Service Bulletin

Bulletin No.: PIT6396

Subject: SES MIL with DTC P2535 / P12A6 / P10DA / C111B / P157A After Fuel Pump Driver Module Replacement 13565642

6954816

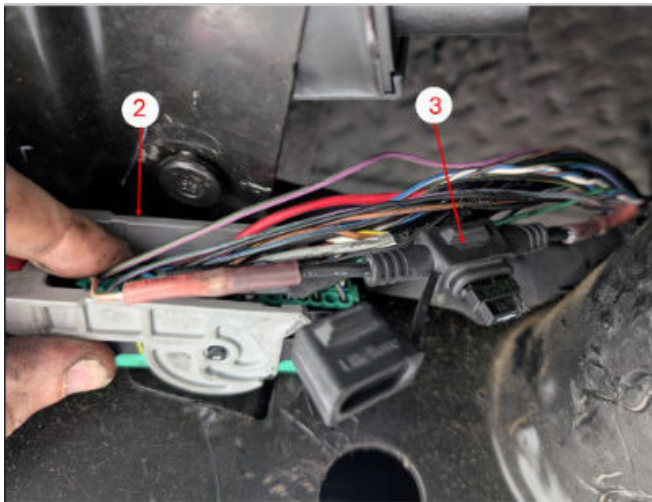
Engineering is working on design improvements for a new fuel pump driver module. In the meantime, a diode can be installed in line with the water-in-fuel sensor circuit 6862, shown below (1), to correct the issue.

1) Locate either the K111 fuel pump driver module connector terminal 1 OR the E11A Fuel Heater/Water In Fuel sensor connector terminal 3, whichever is the most convenient to install a mini inline fuse holder. Next, cut circuit 6862 a few inches from the connector. Then connect a mini fuse holder, see parts sections for details, in line with circuit 6862 using two salmon splice sleeves, as shown below (3). In the example below, the repair is being done at the K111 fuel pump driver module (2) end, but it could be done at the E11A Fuel Heater/Water In Fuel Sensor connector end, whichever is most convenient.

2) Install a fuse style diode, GM P/N 12135037, into the mini inline fuse holder so the arrow on the diode is pointing towards the E11A Fuel Heater/Water In Fuel Sensor, as shown above (1).
